CITY OF ASHLAND

HISTORIC COMMISSION MEETING

AGENDA

May 6, 2015 at 6:00 P.M.

ASHLAND GROWLER
REMODEL
345 LITHIA WAY
ASHLAND, OREGON

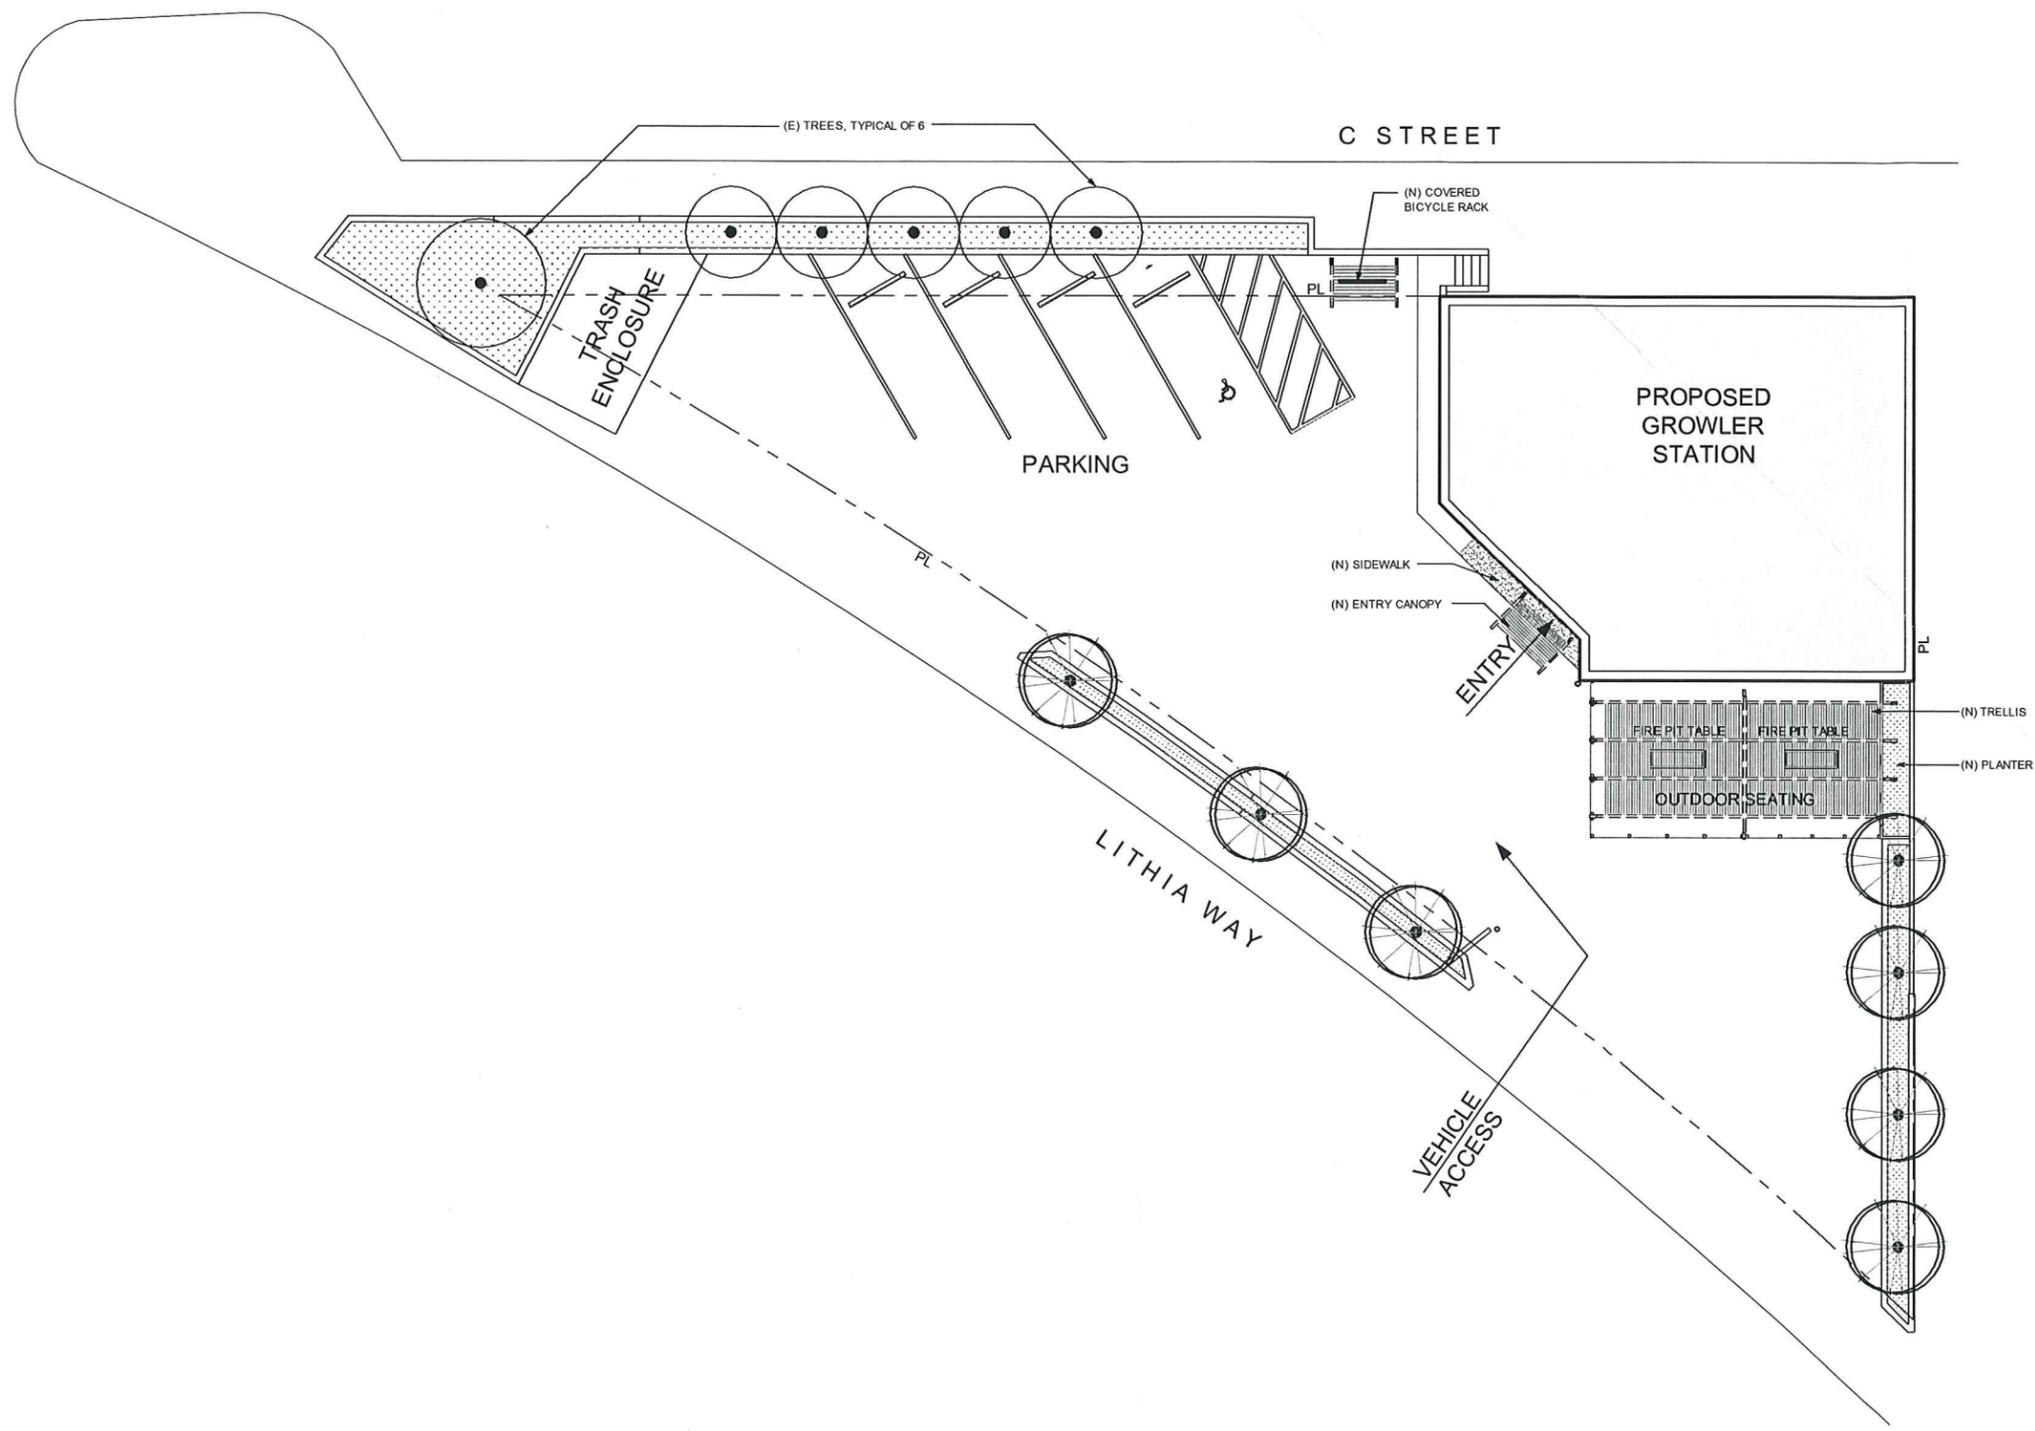
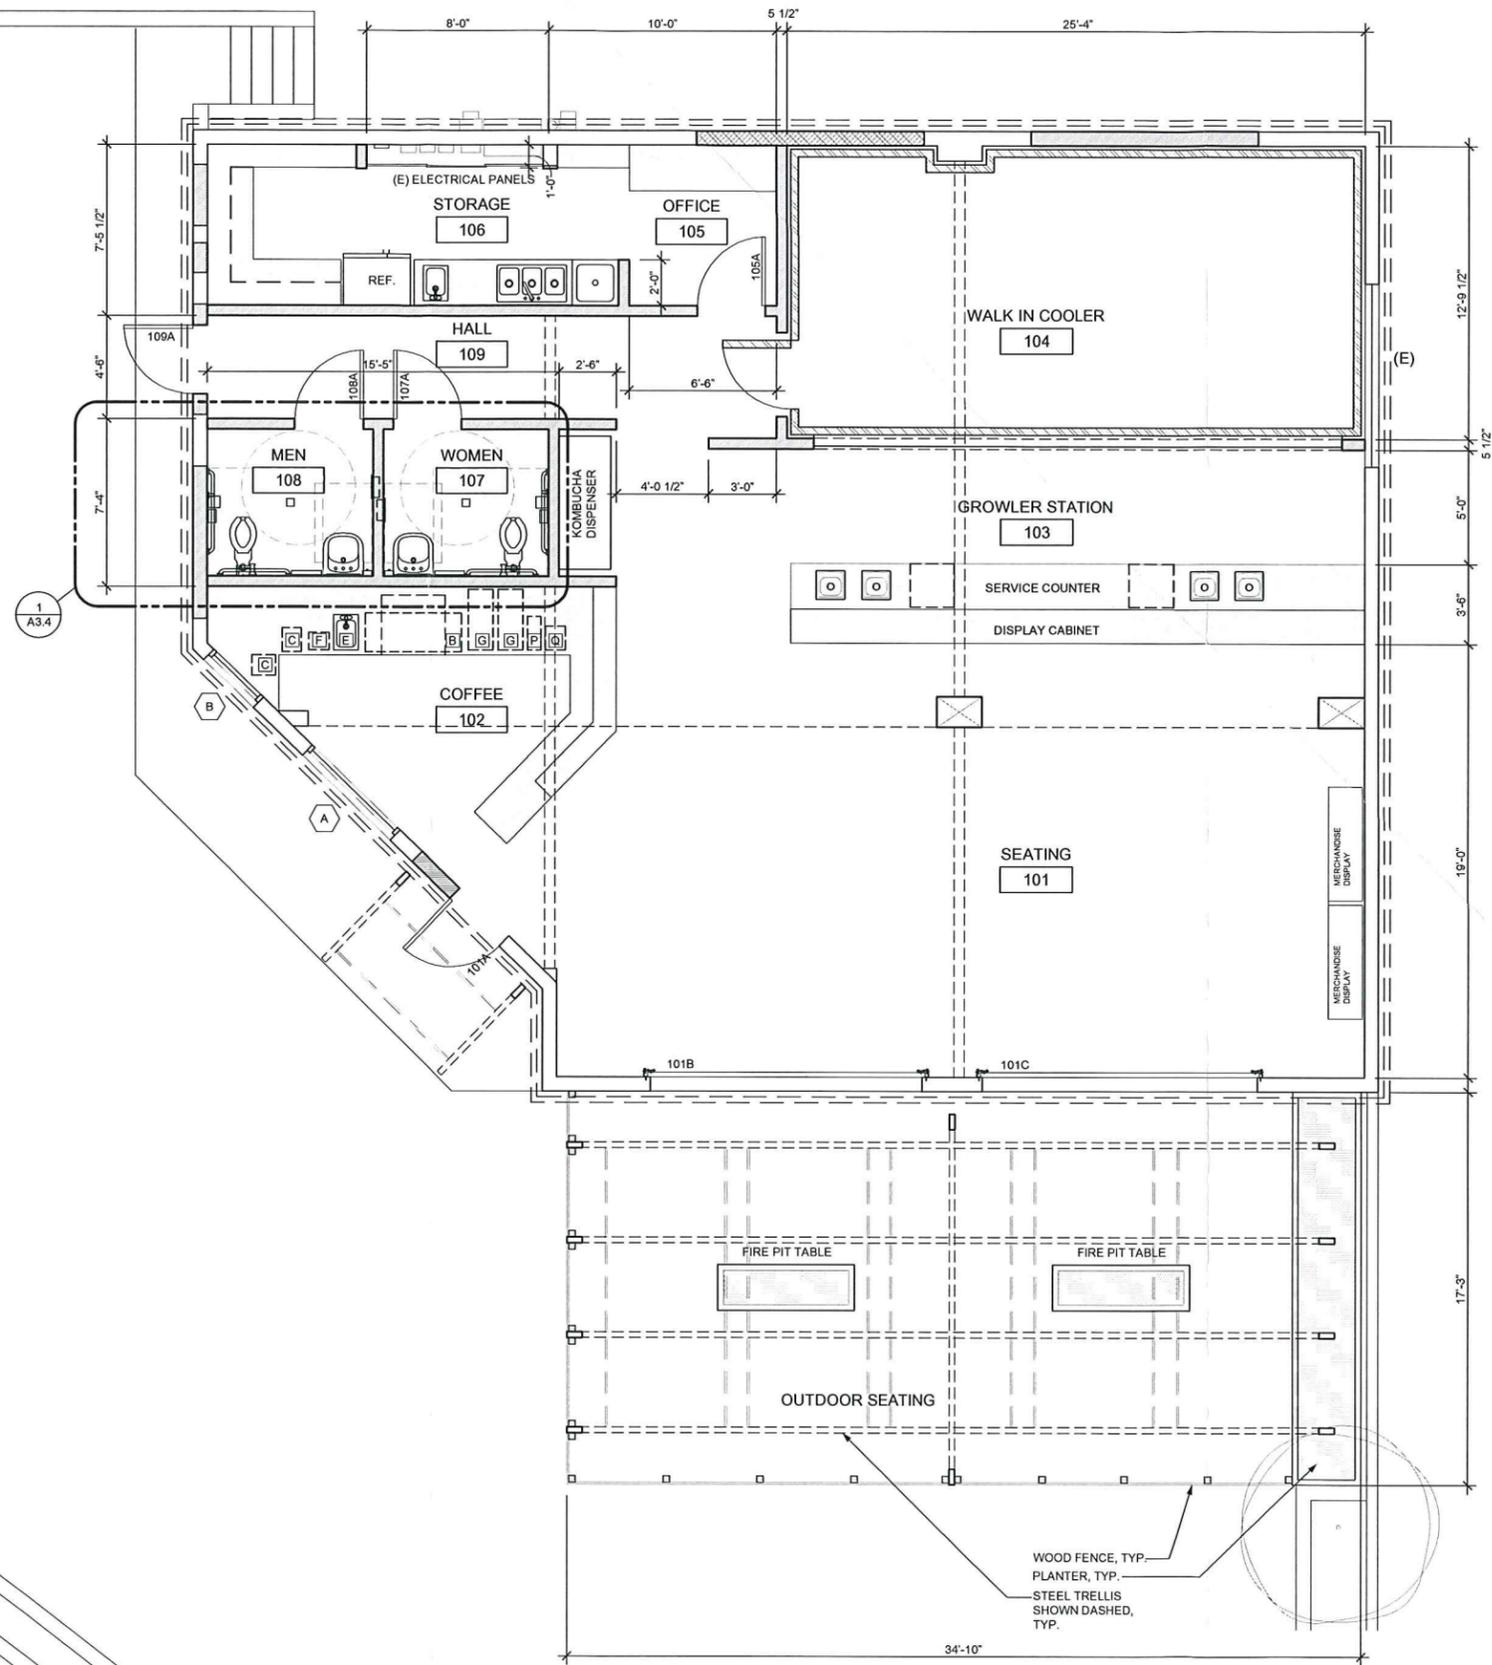
The Historic Commission found that the proposal did not comply with the Historic District design standards for commercial development (AMC 18.4.2.060.C) They found that the wood elements being added were out of scale proportion wise and that the wood and the patterned tile were incompatible with the original architectural character of the building. It was suggested that the tile be monochromatic or a single color and that stucco with control joints or rivulets would create a simple façade, more appropriate for the downtown historic district.

Mr. Shostrom motioned to deny PA-2015-00541. Mr. Whitford seconded. No one opposed.
